Ilonka Aylward  
v.  
City of Charlotte  
and  
Charlotte-Mecklenburg Stormwater Services (a.k.a. “Charlotte Stormwater Services,”  
a.k.a. “Charlotte/Mecklenburg Storm Water,” a.k.a. “Charlotte Storm Water Services,”  
a.k.a. “City of Charlotte Storm Water Services”)  
and  
Armstrong Glen, P.C.  
and  
Joseph (“Josh”) H. Letourneau, P.E.

## **Exhibit 15**

**From:** Amschler, Crystal C CIV USARMY CESAW (USA)  
**Sent:** Wednesday, August 19, 2020 9:53 AM  
**To:** Thames, Kelly  
**Subject:** RE: SAW-2020-01043 Hinsdale-Tinkerbelle SDIP

Thank you for your emails on July 10 and July 15, 2020 regarding questions on the Pre-Construction Notification (PCN) application for the Hinsdale-Tinkerbell Storm Drainage Improvement Project (SDIP). Responses are organized by requesting Agency.

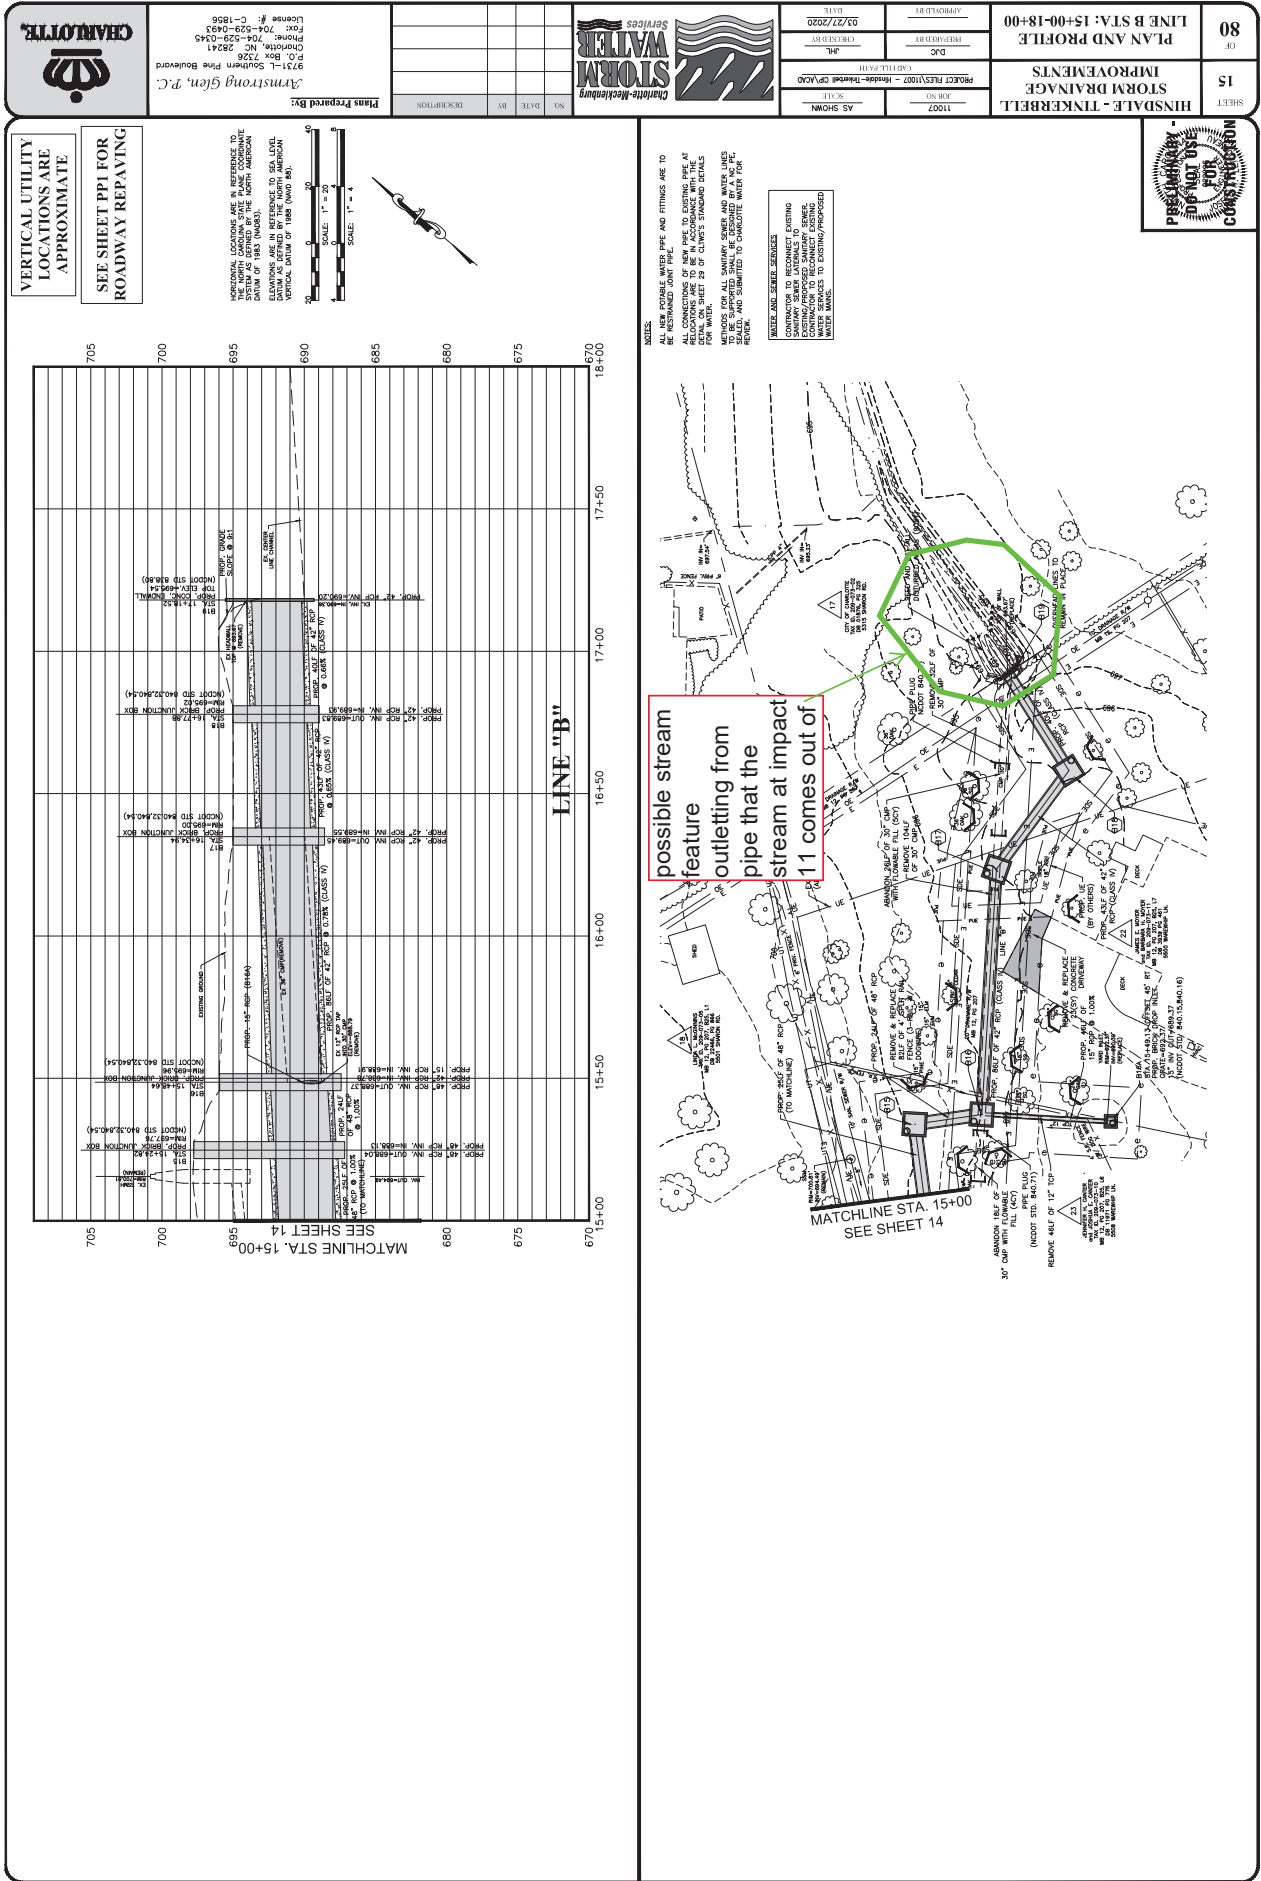
1. First question is about benches and bank work. The plan sheets show impacts where riprap and aprons will be replaced, stream grading and culvert replacements, but no impacts along the banks for benches. Also, the plan shows for the double barrel crossings that the low flow culvert is off to the side with nothing on the plan showing that the stream width will be maintained and the low flow will be directed into the low floor culvert. The D plan series does however show cross sections with benches for each culvert and it looks like from these plans that there will be benches to maintain widths and direct flow into the low flow culverts. It would be helpful if the profile showed the extent of the bank work and benches as well. Also, the bank stabilization/benches should be included as permanent non-loss impacts for bank stabilization.

1) First question is about benches and bank work. The plan sheets show impacts where riprap and aprons will be replaced, stream grading and culvert replacements, but no impacts along the banks for benches. Also, the plan shows for the double barrel crossings that the low flow culvert is off to the side with nothing on the plan showing that the stream width will be maintained and the low flow will be directed into the low flow culvert. The D plan series does however show cross sections with benches for each culvert and it looks like from these plans that there will be benches to maintain widths and direct flow into the low flow culverts. It would be helpful if the profile showed the extent of the bank work and benches as well. Also, the bank stabilization/benches should be included as permanent non-loss impacts for bank stabilization.

On Sheets 5, 6, 7, & 9 the plan set has been updated to note: “SEE SHEET D13 FOR HEADWALL GRADING” with “SEE SHEET D13 FOR HEADWALL GRADING, BENCH GRADING, AND BENCH CROSS SECTIONS”. In addition, a note has been added on each of those sheets that states, “Benches upstream and downstream of the culvert will be constructed as designed, unless areas of bedrock identified during construction prohibit bench grading.”

HINSDALE-TINKERBELL SDIP  
IMPACT LOCATIONS  
FIGURE 6.4

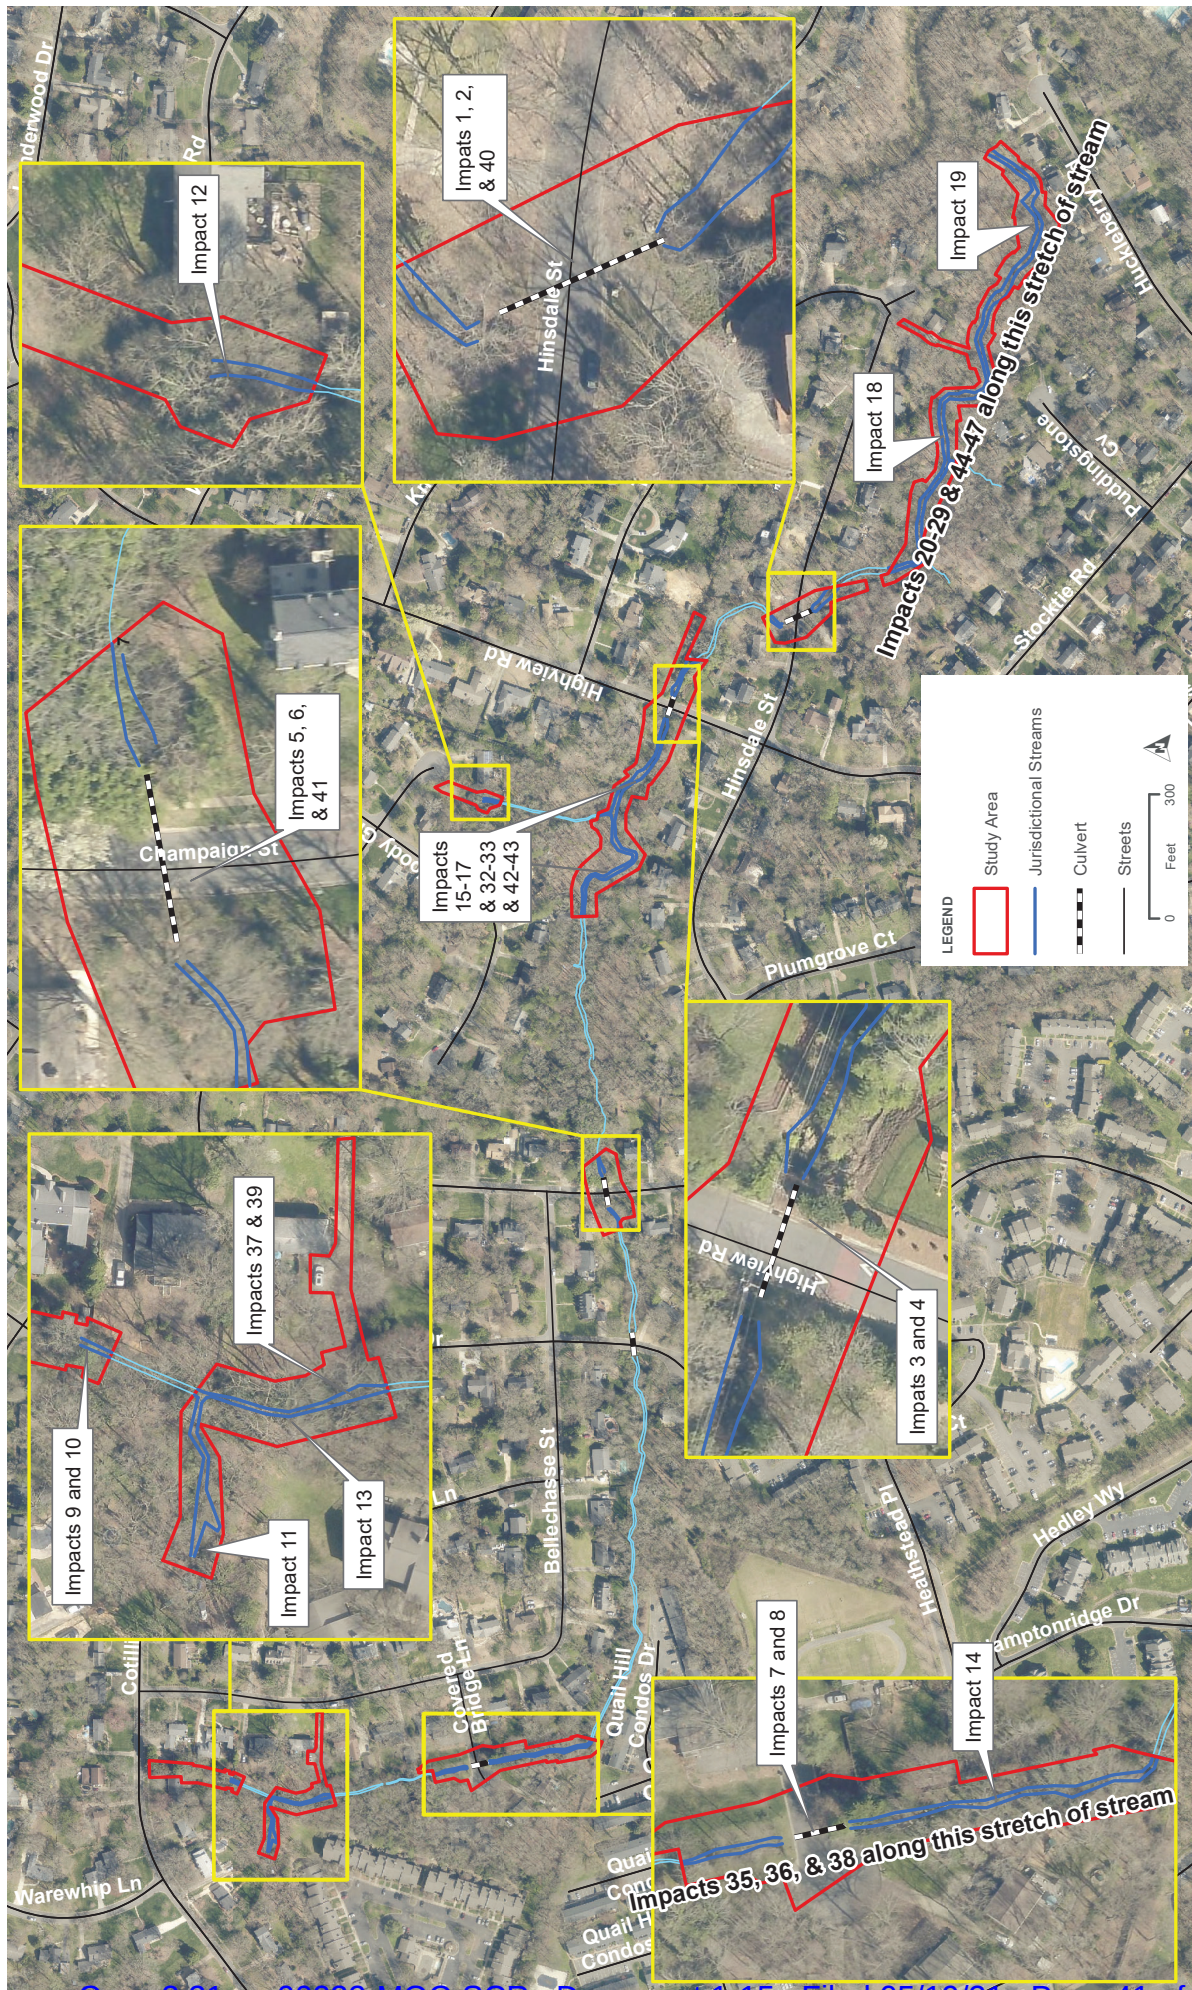
6. Please provide overall plan sheets that show the locations for the EC and U series of plan sheets so I know where the impacts these plans show are located.

6) Please provide overall plan sheets that show the locations for the EC and U series of plan sheets so I know where the impacts these plans show are located.

Impacts 9, 10, and 11 are within the review area. Please see the attached figure noting the Impact #s and their locations. Sheet 11 connects with Sheet 10, which follows a stormwater pipe system beneath Cotillion Avenue resulting in Impacts 9 and 10 at the outlet.

Attachments:                      Figure 6.4. Impact Locations  
   Overall Figure for EC and U Plan Set Series
